***In the Matter of the Application of Summit Lake
Solar, LLC for an up to 200 MW Summit Lake Solar
Energy Generating System Site Permit for the Summit
Lake Solar Project in Nobles County, Minnesota***

**JOINT SITE PERMITS
APPLICATION AMENDMENT**

MPUC Docket Number IP-7150/GS-25-89

MPUC Docket Number IP-7153/ESS-25-88

Figure 1.0-1 shows a comparison of the updated Preliminary Development Area and the Preliminary Development Area described in the Joint Application.

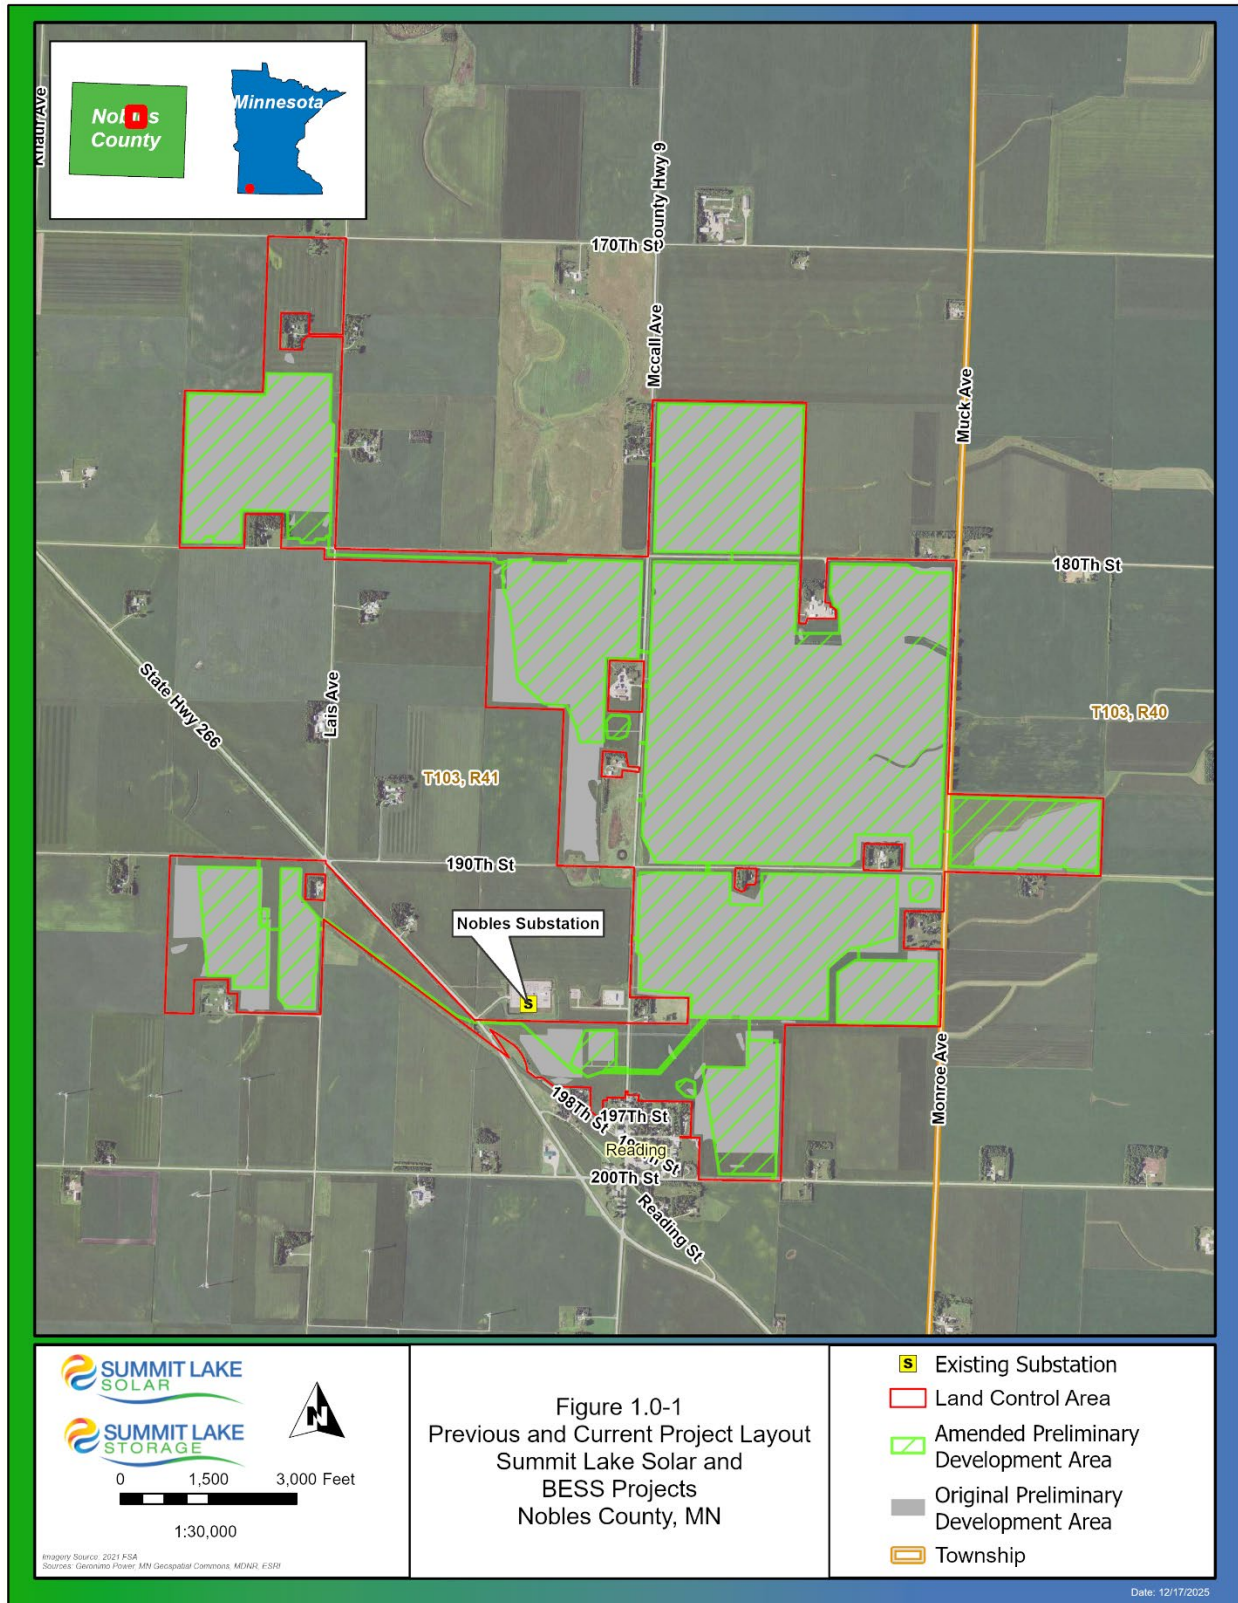
The Solar Facility layout has been updated, including rearrangement of blocks of solar arrays, inverters, the Project Substation, security fencing, access roads, and collection and communication lines to avoid and/or minimize impacts on County Drain Tile in the Land Control Area and residential homes near the Project. Solar Facility setbacks from non-participating property lines, residences, public roadways, and County Drain Tile have been increased. In addition, the following changes have been incorporated into the preliminary Project design:

- the BESS has been moved north-northeast to reduce noise impacts on sensitive receptors, increase the distance between the BESS and the city of Reading, and to avoid collection lines associated with the Nobles County Wind Farm;

- the Preliminary Development Area has decreased by approximately 65 acres;
- the O&M facility has been moved from inside the BESS facility fenceline to adjacent to the Project Substation;

- laydown yards have been relocated and consolidated to four new yards impacting fewer acres, although the final number of laydown yards may change based on the needs of the contractor chosen to construct the Project;

- the length of the gen-tie line has decreased by approximately 108 feet; and
- stormwater ponds have been relocated and consolidated into 13 larger stormwater ponds, resulting in increased acreage, provided the final number of stormwater ponds may change based on final design and compliance with applicable stormwater requirements.
